NRL/MR/7441--93-7080

# Digital Mapping, Charting, and Geodesy Analysis Program Technical Review of Urban Vector Smart Map (UV<sub>Map</sub>) Prototype 1

March 11, 1994

Figure 1. Possible digitizing error / Water courses showing "broken" lines.

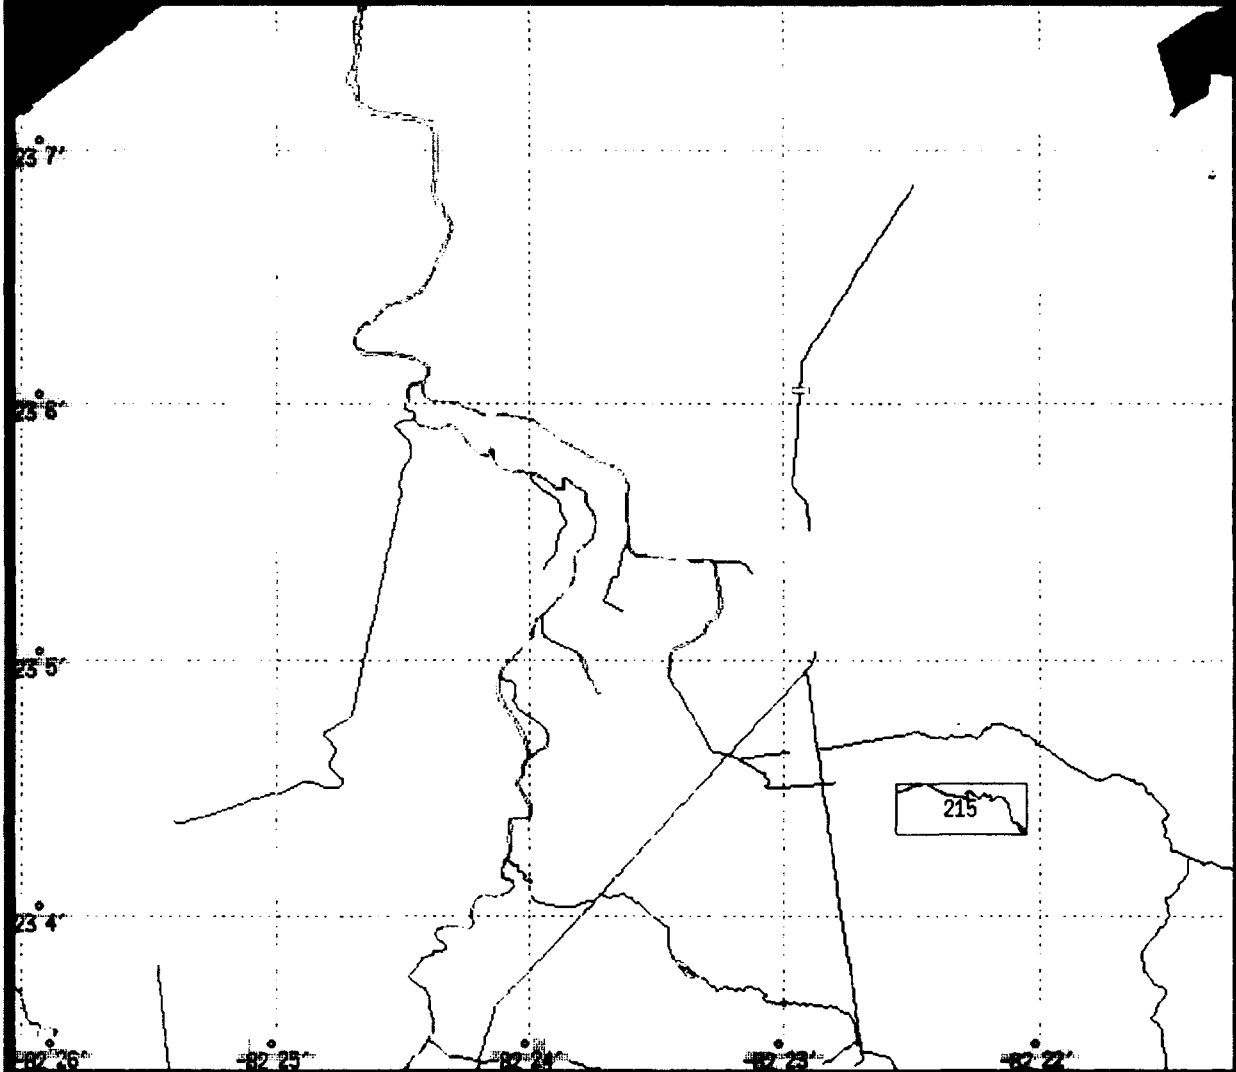
- Only one discrepancy has been detected in comparing the Havana city graphics with the digital version. Figure 1 displays a river/stream (EDGE 215) in the database that does not appear in the source charts. This could be a digitizing error or an update to the actual city graphic. If EDGE 215 is an update from the chart, this fact should be indicated.

1. A fundamental problem, relating to UV<sub>Map</sub>'s potential usefulness in GIS applications, is its inability to recognize complete objects when more than one feature comprises that object. Figure 1 demonstrates this phenomenon. Several water course lines appear to be broken, to the point that the average user could wrongly conclude that dry land was present between the water courses. In this particular view, however, some of the breaks are filled-in when aqueducts are displayed.

EDGE 215:  
Database: /dmap\_home/uvmap1  
Library: HAVANA  
Coverage: HYDRO  
WATCRSL.LFT: Water Course Line Feature Table -  
ID - Row ID: 70  
F\_CODE - FACC Code: BH140 (River/Stream)  
ACC - Accuracy Category: 0 (Unknown)  
EXS - Existence Category: 0 (Unknown)  
HYC - Hydrological Category: 6 (Non-Perennial/Intermittent/Fluctuating)  
LMC - Landmark Category: 0 (Unknown)  
WID - Width (meters): 0 (Unknown)  
TILE\_ID - Tile Reference ID: 2  
EDG\_ID - Primitive ID: 215
